# Purbachal Apparel Ltd.

South Panjora, Ward#05, Nagori, Gazipur  
(23.888930N, 90.502231E)  
10<sup>th</sup> June 2018

# Observations

# Corrosion observed at steel sections

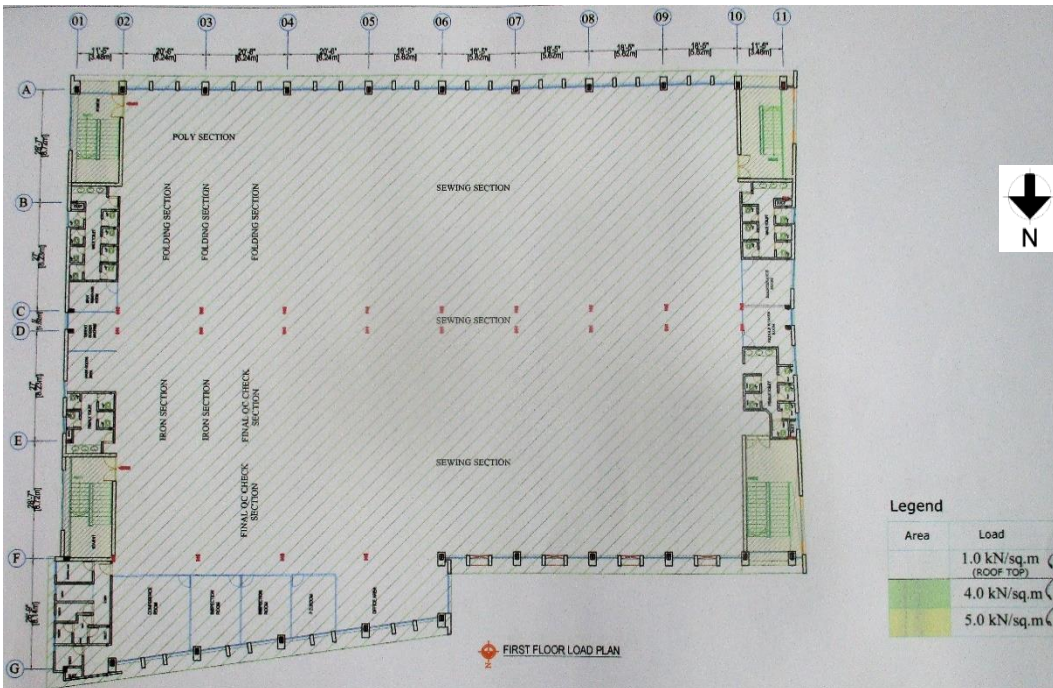
Corrosion was observed at joint of deck slab and steel column of 1<sup>st</sup> floor in production areas.

Corrosion was observed at joint of pedestal column and steel column.

Corrosion was observed on steel columns on different locations of 1st and ground floor areas. Factory is required to identify the corroded locations and take proper remedial measures.

# Capacity check of cantilever beam supporting stair

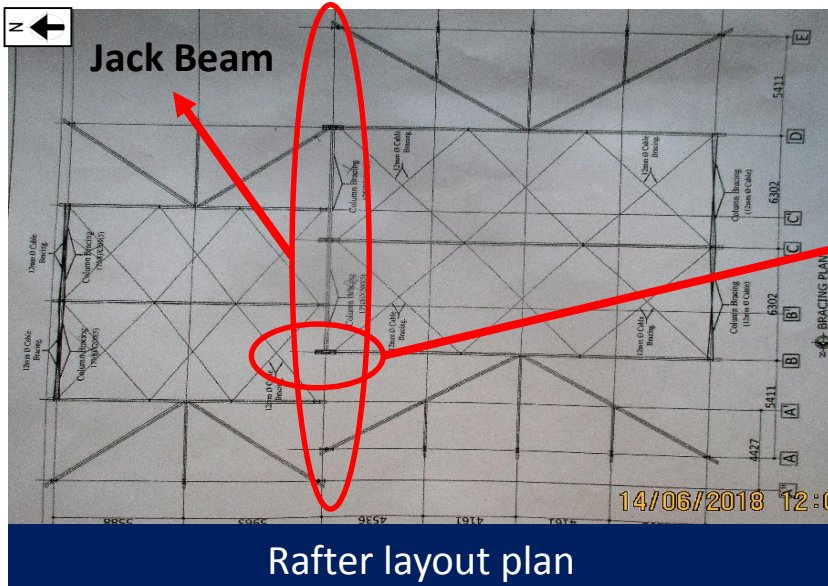
Concerns on cantilever beam supporting external stair case. A capacity check of the cantilever beam need to be carried out.

The external stair is supported by cantilever beam

7	(Utility building) Capacity check of cantilever beam supporting stair	Factory Engineer to review design, loads and related elements in area identified above to confirm capacity for the stair.	6-weeks
8	(Utility building) Capacity check of cantilever beam supporting stair	Carry out remedial works resulting from capacity check if necessary.	6-months

Rafter layout plan

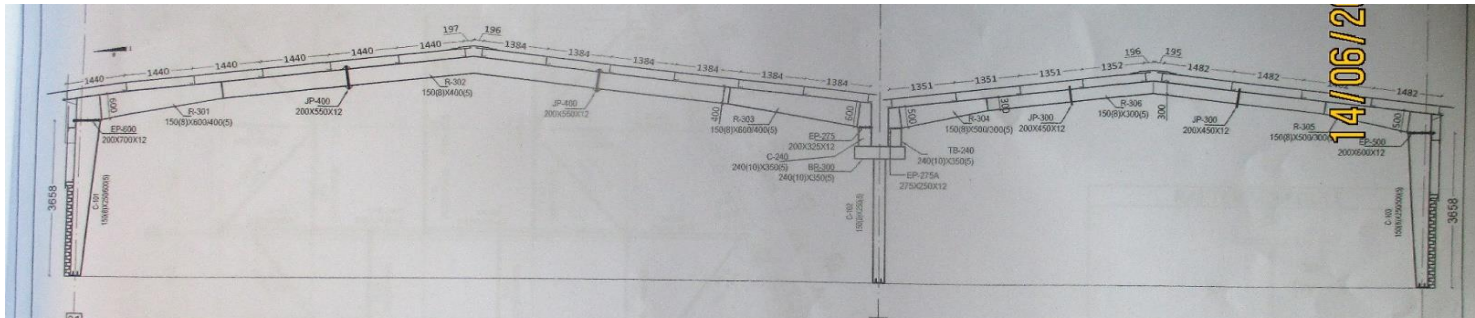
From the layout plan and visual inspection it was observed that the lateral stability of the structure partly depends on the jack beam as some of the rafter are resting on it. Apparently no obvious lateral load resisting system on north-south direction due to insufficient of lateral load transfer media. Factory engineer is require to verify the lateral stability of the structure against the horizontal and vertical loads.

Item No.	Observation	Recommended Action Plan	Recommended Timeline
9	(Welfare shed) Lateral stability system to be verified	Factory engineer to check the stability of the structure under vertical and horizontal loads.	6-weeks
10	(Welfare shed) Lateral stability system to be verified	Carry out remedial works resulting from engineering assessment if necessary.	6-months
11	(Welfare shed) Loose cable bracing	Loose bracings are required to be tighten as per suggestion of the factory engineer.	6-weeks
12	(Welfare shed) Discrepancies between drawings and on-site observation	Factory is require to install the bracings as per bracing layout drawings.	6-weeks
13	(Welfare shed) Discrepancies between drawings and on-site observation	Factory engineer is required to update as-built documentation reflecting the actual condition.	6-weeks

# Loose cable bracing

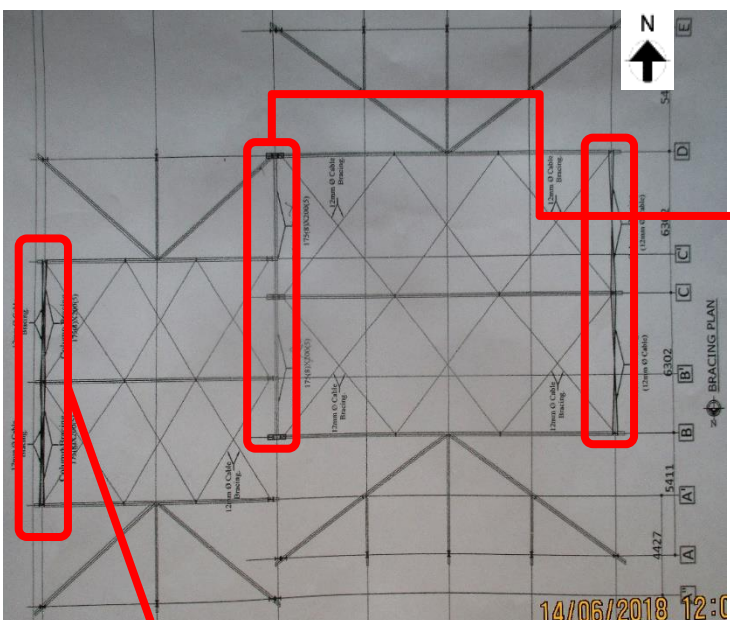
Loosely tied vertical cable bracing at east side

Loosely tied vertical cable bracing at west side

Loosely tied roof cable bracing

Some of the horizontal and vertical cable bracings are appeared to be loosely tied. Factory is required to tighten the bracing for transferring lateral loads properly

As-built drawing Bracing Layout

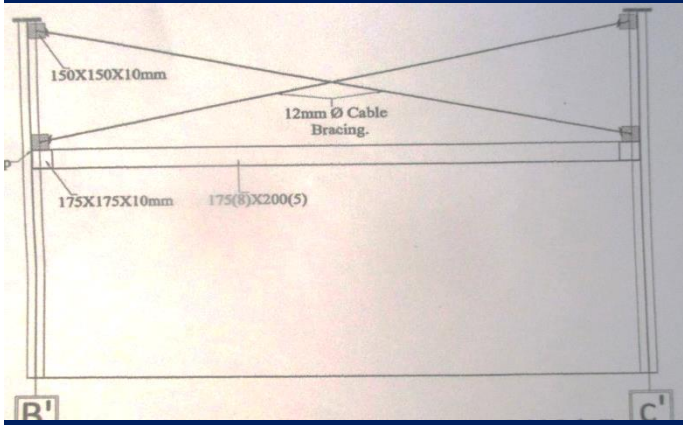
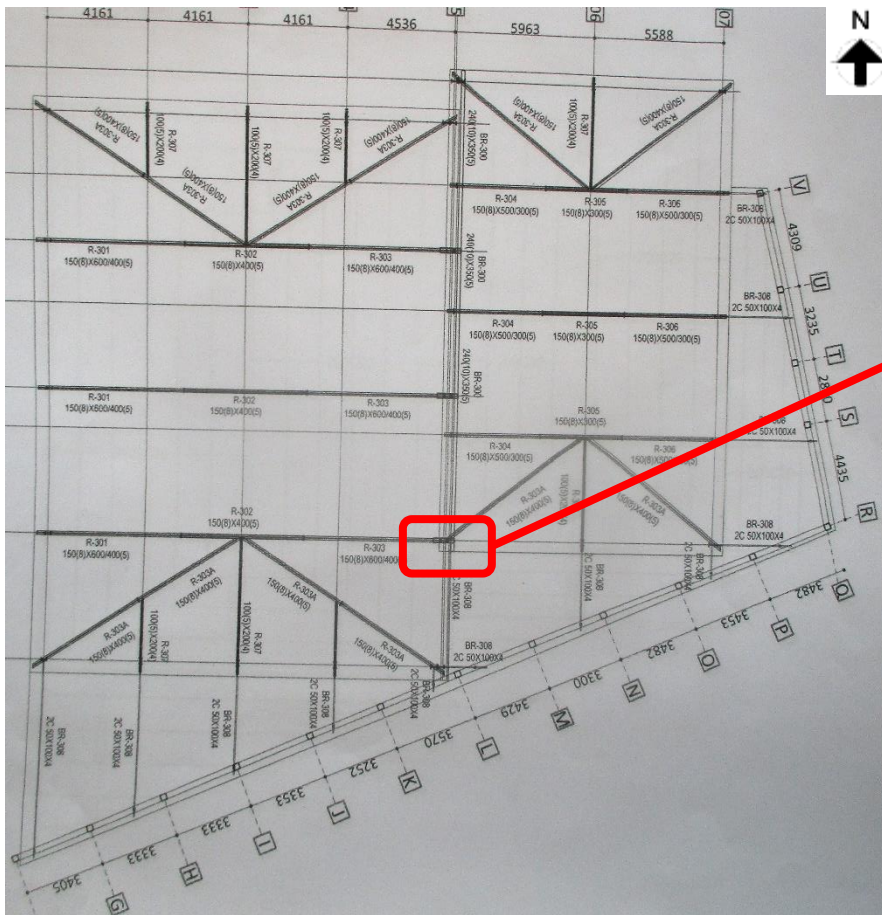
No column bracing was found on site in grid 5B-5C, 5C-5D, 7A'-7B' & 7B'-7C'

The location of column to column vertical bracing didn't match with provided bracing layout drawings. Factory is require to install the bracings as per bracing layout drawings.

Only cable bracing was found in grid 1B-1C & 1C-1D but no compression strut was observed.

Vertical bracing with compression strut in as-built drawing

Rafter Layout in as-built drawing

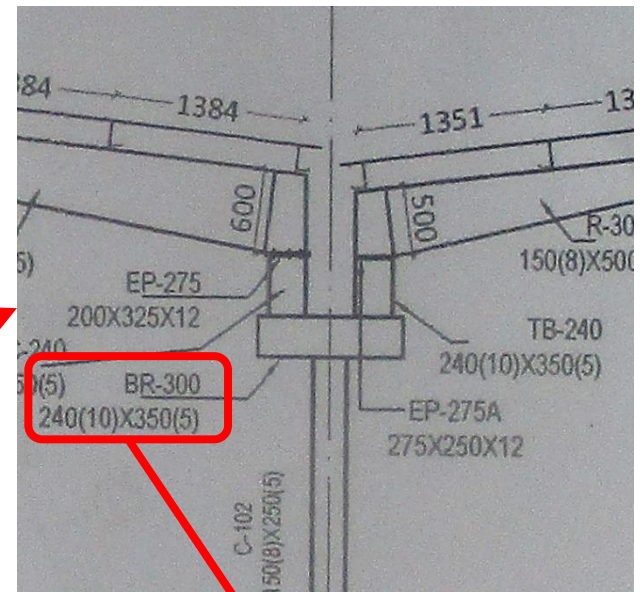
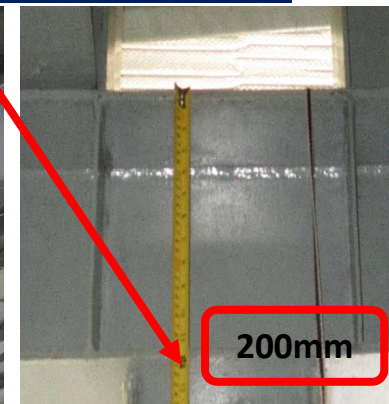
The size of Jack beam at grid B-5 was found F200mm (10mm) X W300mm(5mm) which was supposed to be F240mm (10mm) X W350mm(5mm) as per provided as-built structural drawing.

Jack beam BR-300 at grid B-5

Depth of Jack beam measured on site
